# SERVICE BULLETIN

Classification: EC01-001	Reference: NTB01-010	Date: February 15, 2001
-----------------------------	-------------------------	----------------------------

## BUZZ NOISE AFTER ENGINE IS TURNED OFF

**APPLIED VEHICLE:** 2000-01 Maxima (A33) – A/T vehicles only

Figure 1

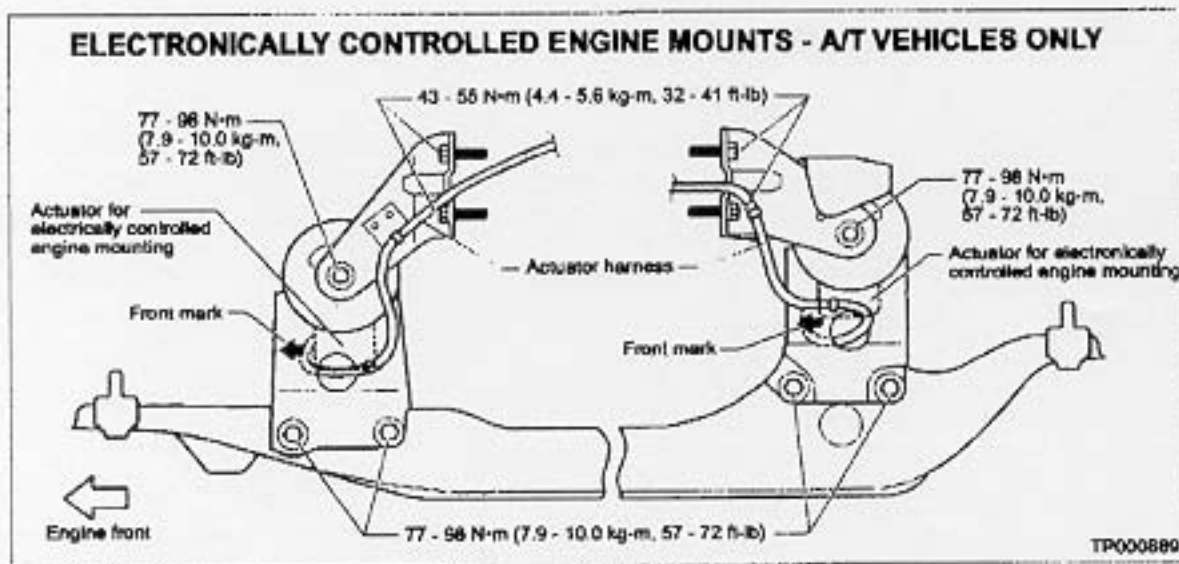
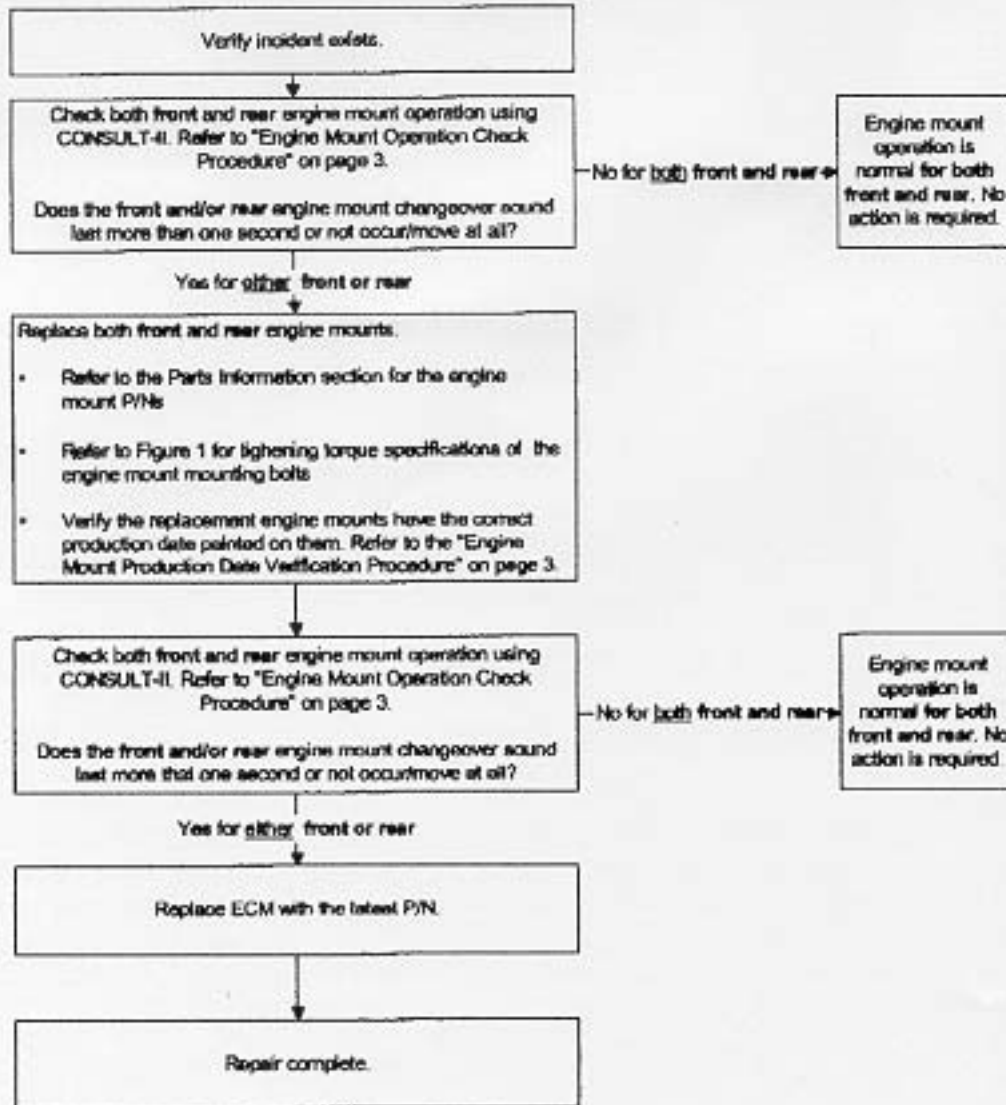
If an applied vehicle exhibits a buzzing noise coming from the engine compartment for several seconds after the ignition key is turned off, the cause may be the electronically controlled engine mounts. Use the Diagnosis / Repair Flow Chart on page two to diagnose and repair the vehicle.

Each engine mount has a production date code painted on it. The date code is made up of four digits and can be determined by using the date code example listed below.

Use the date code example below to make sure your replacement engine mounts have a date code of September 4, 2000 or later. Replacement engine mounts with earlier dates should not be used.

#### Date Code Example "0I04":

"0" number indicates the manufacturing year of 2000

"I" letter indicates the manufacturing month of September (9<sup>th</sup> month in alphabetical order)

"04" numbers indicate the manufacturing day of the 4<sup>th</sup>
